ORIGINATION FORM

Proposed Revisions to a Standard Plans Index
(Please provide all information — Incomplete forms will be returned)

Index Number: 715-003
Sheet Number (s): 3
Index Title: UTILITY CONFLICT POLE

Sheet 3: Added Foundation Note 3 to allow for precast foundation with an octagon shape as a substitute for the circular shaped foundation shown.

FOUNDATION AND BASE DETAILS

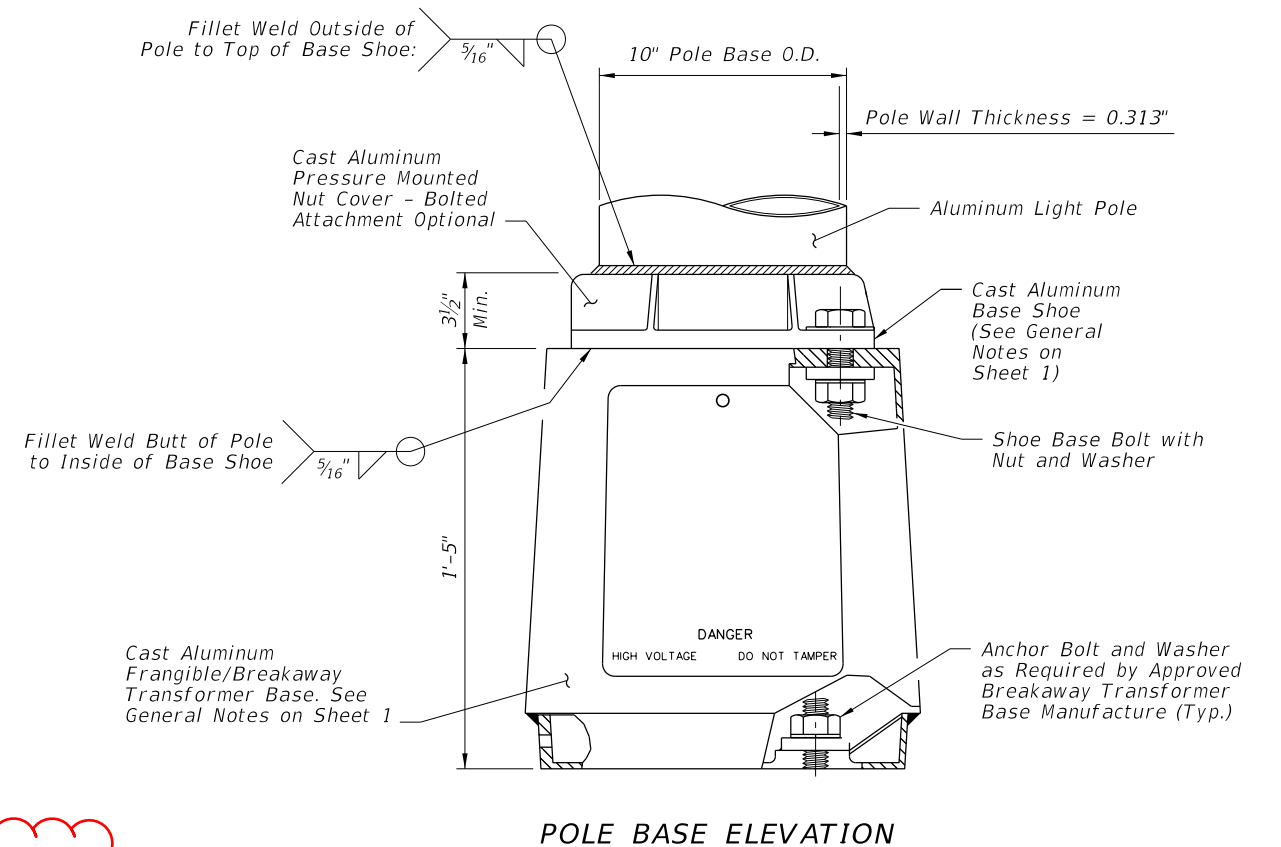
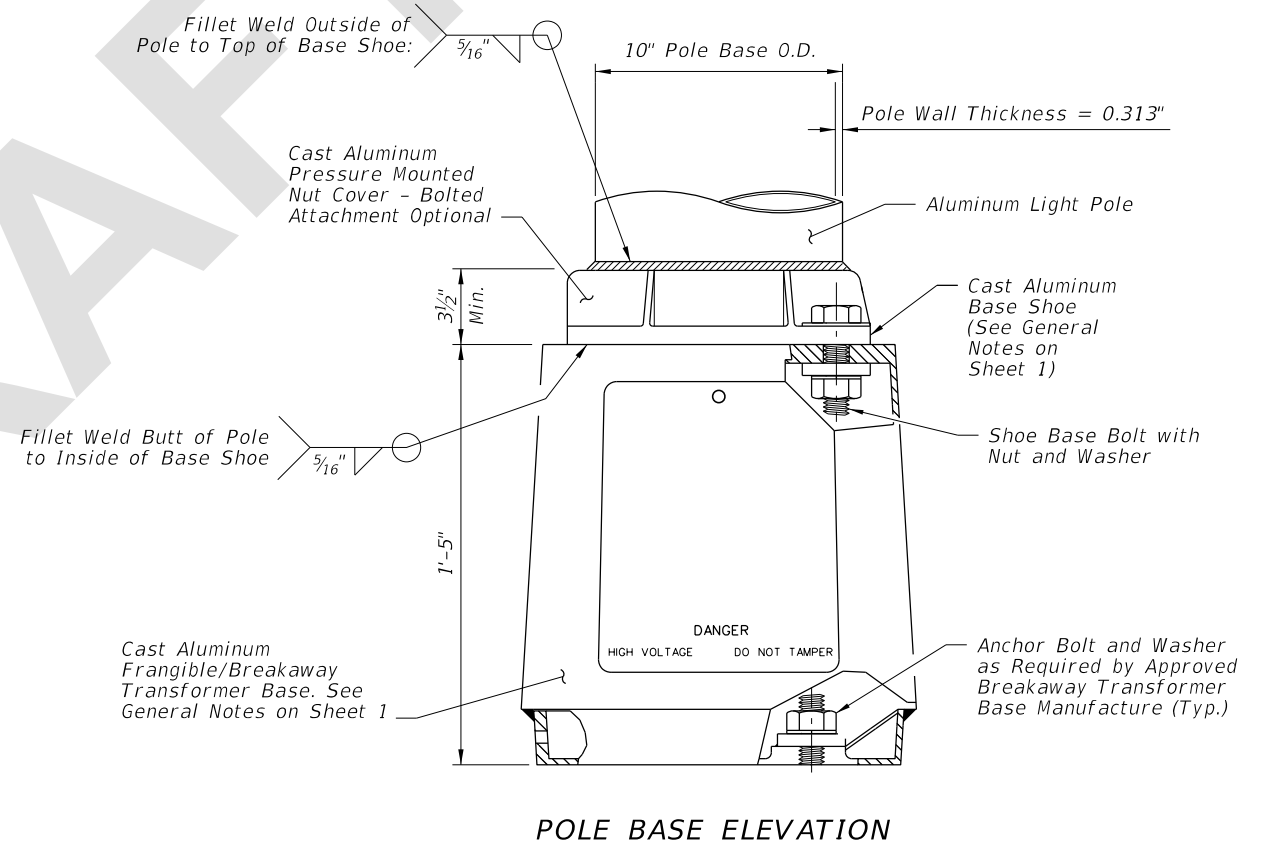
Sheet 3: A non-circular, octagon shaft foundation option was requested by industry to simplify formwork.

Added Note 3 for Precast Octagon Shaped Foundation Option

1. Depths shown are for slopes equal to or flatter than 1:4. For slopes steeper than 1:4 and equal to or flatter than 1:2 add 2'-6" to foundation depths shown.
2. Foundation Tie Bars: #4 Tie Bars @ 12" centers (max.) or D10 (or W10) spiral @ 6" pitch, 3 flat turns top and 1 flat turn bottom.
3. For precast foundations, the circular cross section shown may be substituted with an octagon shape. The out-to-out distance between parallel edges of the octagon must be ≥ 2'-6". Use the same reinforcing diameter and centered placement with a minimum 3" cover.
